Zoning Staff Report

Case Number: SP-25-002

Site Plan

Request: Add site plan for “PD1090” Planned Development for "D" High Density Multifamily.

PD SITE PLAN
SITE PLAN
SP-25-002

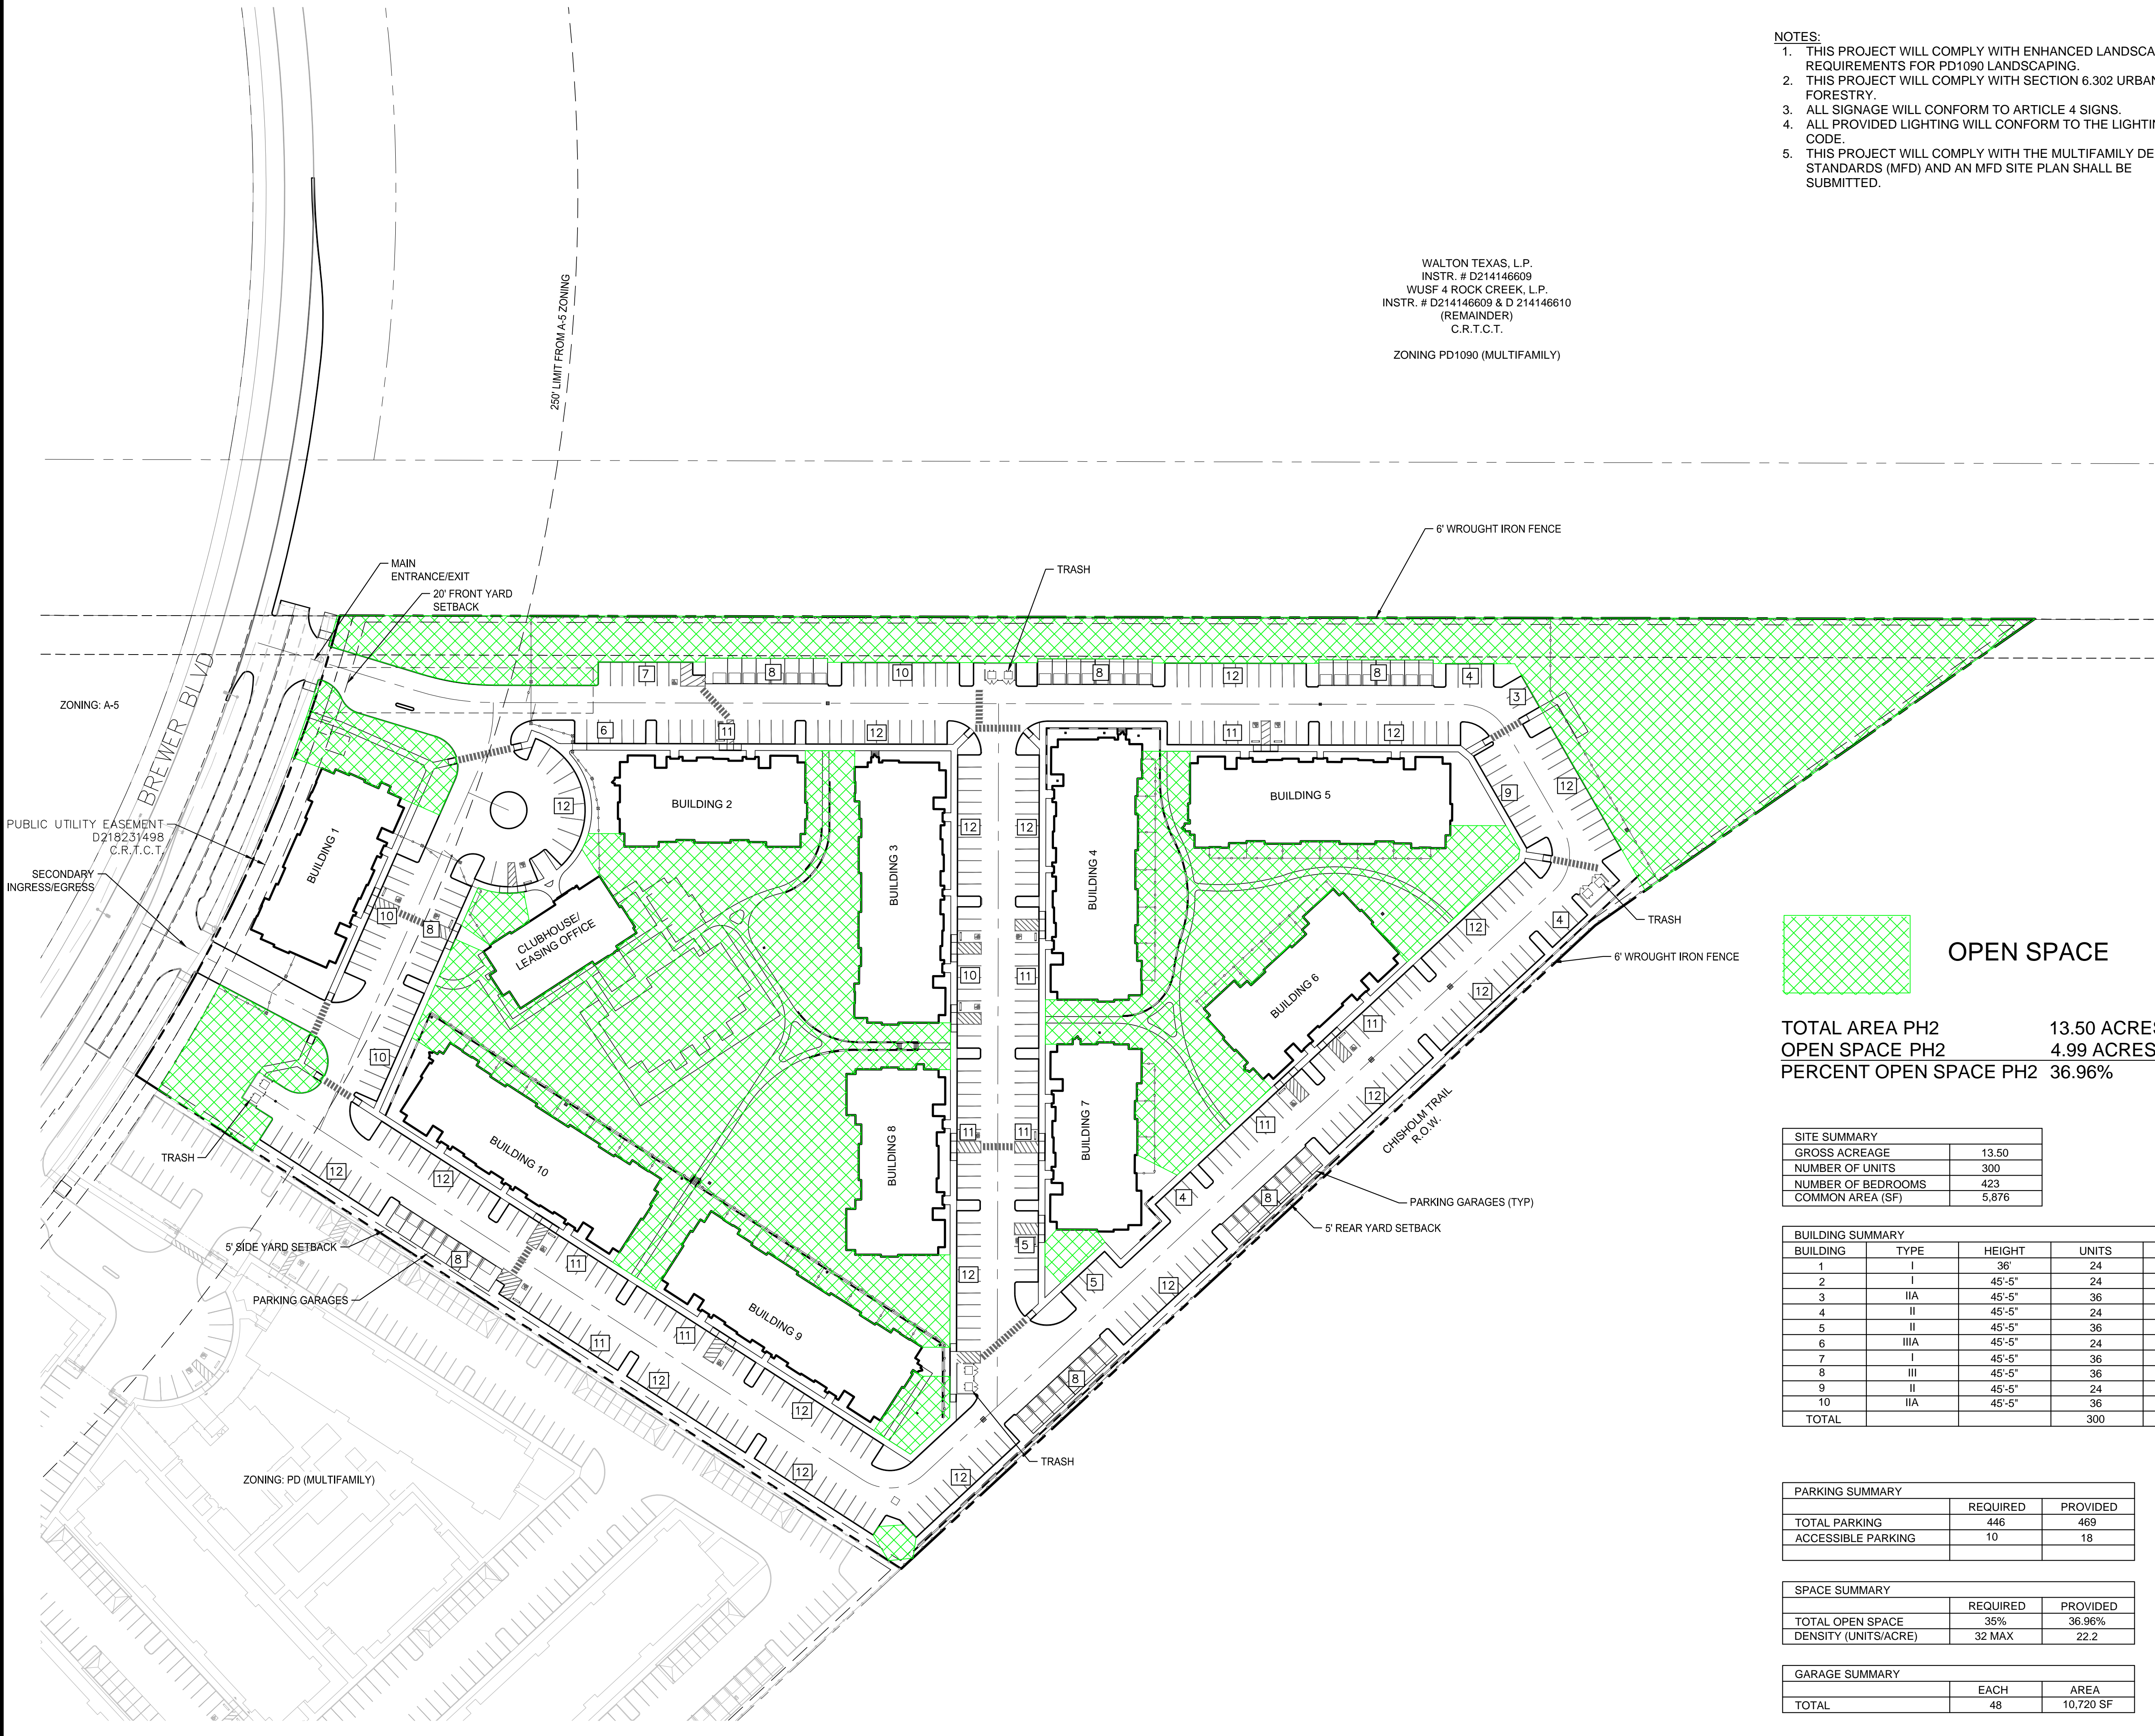
1. Add the correct site plan number in the lower right-hand corner.
2. Minimum open space requirement is 35% must comply or a waiver will be required through a zoning case amendment to the PD.
3. Provide on the site plan the setback distance from the A-5 single family district to the first building. 36 ft. is the maximum height if within 250 ft. This would also require a waiver through a zoning case amendment to the PD.

FYI: CORRECTIONS REQUIRED: Show and label widths of fire lanes.

All access roads will have to be built above 100 year floodplain.

Two points of access are required from projects having more than 100 units.

Fire lanes must be a minimum of 26' wide and provide hose lay to the exterior of each structure within 150', measured in a 5' wide unobstructed path from the edge of a marked fire lane or public street. That distance MAY be increased to 300' if the building is equipped with a fire sprinkler system.

1. Turnaround required between any gate and street
2. Minimum driveway spacing on Brewer is 200 feet. Show distance between site driveways and neighboring driveways
3. Ingress AND egress required in two locations. Cannot have only one ingress or only one egress
4. Show parking aisle size - must be at least 24 feet between 90 degree parking stalls

1. HOLD - 6/24/25 - Provide all proposed water and sewer easements for appurtenances and /or mains.
